PZ&B Staff Combination Memorandum: Landmarks Preservation Commission and Town Council

SUBJECT: ZON-23-095 (HSB-23-007) 124 PARC MONCEAU (COMBO)

MEETING: FEBRUARY 21, 2024, LPC
MARCH 13, 2024, TC

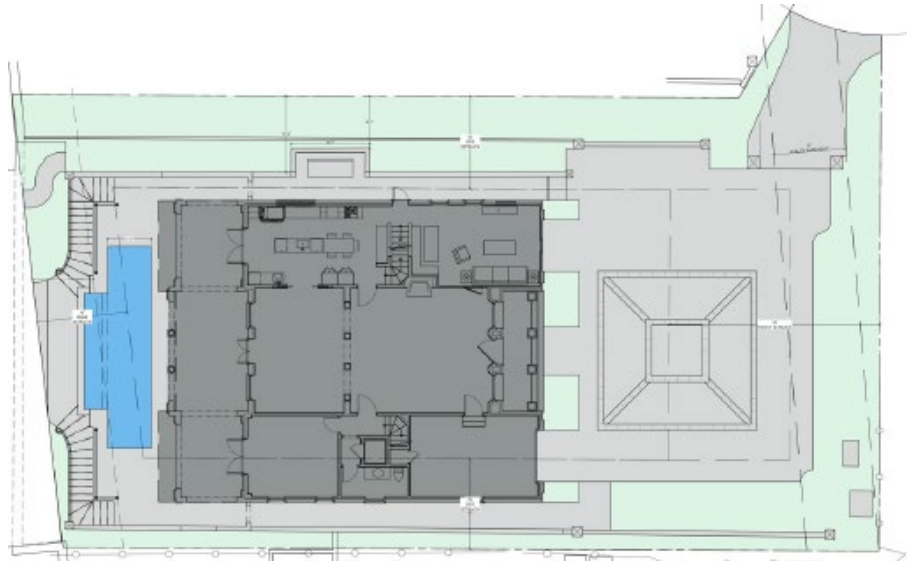
As it pertains to Variance 3, the applicant is proposing a lot coverage of 28.5% in lieu of the 29% and the 25% maximum proposed. The loggia at the rear of the property is being demolished and reconstructed as part of the necessary demolition and reconstruction of the raised pool deck. The proposed reconstructed loggia will be smaller than what is existing, which overall improves the existing lot coverage. While the existing nonconforming lot coverage is improving, the nonconforming lot coverage will need to be reverted due to demolition of over 50% of the west façade.

Code Section	Required	Proposed	Variance
VARIANCE 3: Sec. 134-843(a)(11)b	Maximum Lot Coverage of 25%	Lot Coverage of 28.5% (in lieu of 29% existing)	+ 3.5% Over Maximum

Variances 4 and 5 pertain to landscape open space minimums. Variance 4 to provide deficient overall landscape open space and variance 5 to provide deficient front yard landscape open space. Similar to the other variances, the existing landscape open space on site is already nonconforming at 30.2% provided overall, and 43.2% provided in the required front yard area. As a part of the proposed renovations to the site, the landscape open space is improving, with 10% additional landscape open space being added, however, it still under the minimum requirements; as such, variances are required. The proposed landscape open space diagram is shown above.

Code Section	Required	Proposed	Variance
VARIANCE 4: Sec. 134-843(a)(12)(a)	Minimum Overall Landscape Open Space of 50%	Overall Landscape Open Space of 30.2% (in lieu of 20.6% existing).	19.8% Under Minimum
VARIANCE 5: Sec. 134-843(a)(12)(b)	Minimum Front Yard Landscape Open Space of 45%	Front Yard Landscape Open Space of 43.2% (in lieu of 36.9% existing)	1.8% Under Minimum

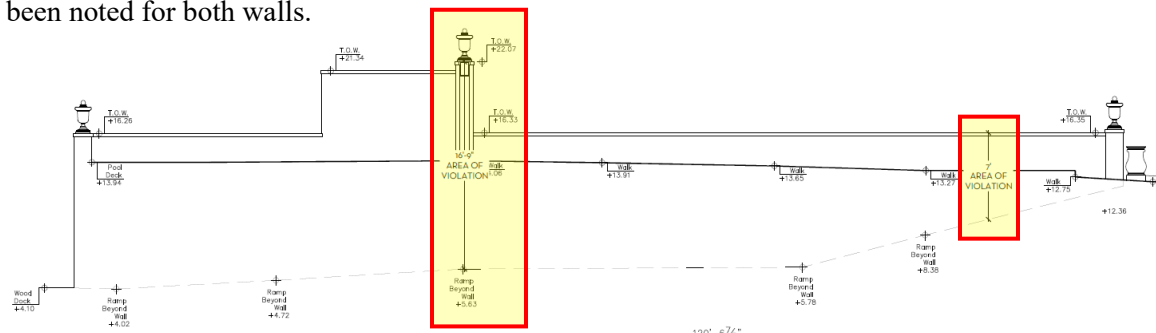
Variances 7 and 8 pertain to perimeter site wall heights. The parcel has a significant change in grade, sloping downwards towards the Lake Worth Lagoon. The significant change in grade has created an existing condition where the height of site walls varies greatly. On the north, the grade starts at roughly 12' NAVD and slopes all the way down to almost 4' NAVD at the west on the pedestrian ramp. On the south, the grade starts at roughly 12.5' NAVD on the east and works its way down to about 3.5' NAVD at the west property line. With the combination of the changes in grade and the height of the walls being raised to provide privacy for the subject parcel, variance requests are required. Staff notes that the grade condition is existing on site. The extremities occur at several different points across the span of the walls, so for clarity the least expanse of variance and the greatest wall high increase have been noted for both walls.

Code Section	Required	Proposed	Variance
VARIANCE 7: Sec. 134-1669	Maximum Wall Height of 7'	Varying wall height of 7.1' to 16.75' at north	0.1' to 9.75' higher.

VARIANCE 8: Sec. 134-1669	Maximum Wall Height of 7'	Varying wall height of 10.67' to 15.33' at south	3.67'to 8.33' higher.
------------------------------	---------------------------	---	------------------------------

SITE PLAN REVIEW

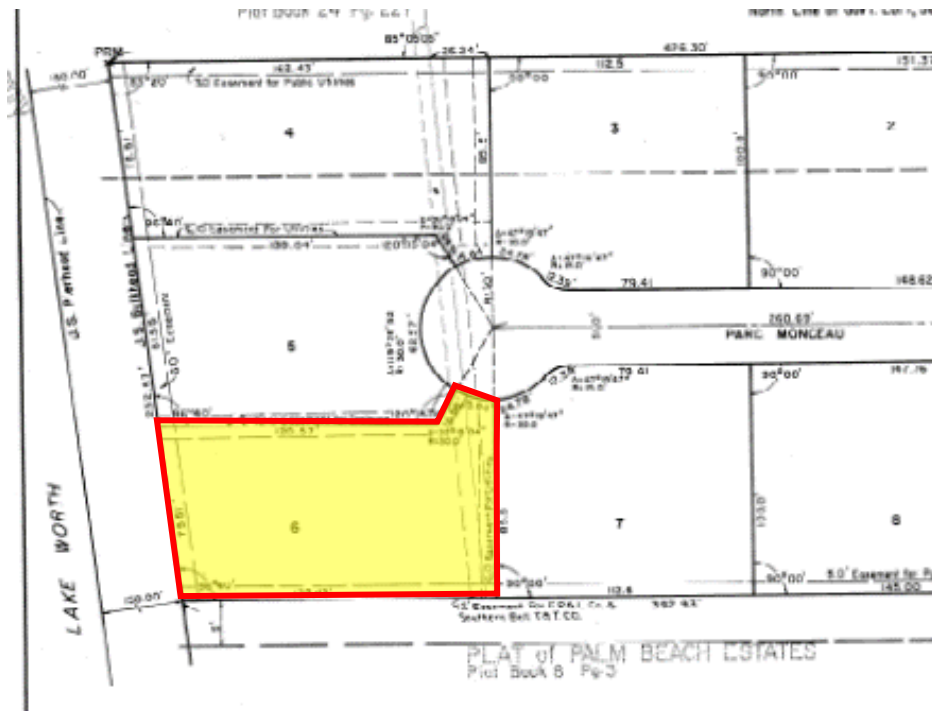
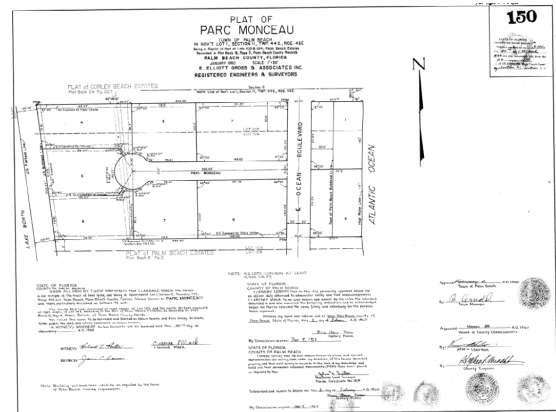
As it pertains to the request for Site Plan Review, development of nonconforming parcels of land must be reviewed by the Town Council. As this lot is comprised of a single platted lot (Parc Monceau Lot 6) in the subdivision, only Site Plan Review by Town Council is required. The existing irregularly shaped lot is 75.51' in width (in lieu of the 125' required), 135' in depth (in lieu of the 150' required) and 10,722 square feet in area (in lieu of the 20,000 square feet required). Because of the loss of more than 50% of an elevation as part of the renovation, approval of the development the existing nonconforming improved site must be revested.
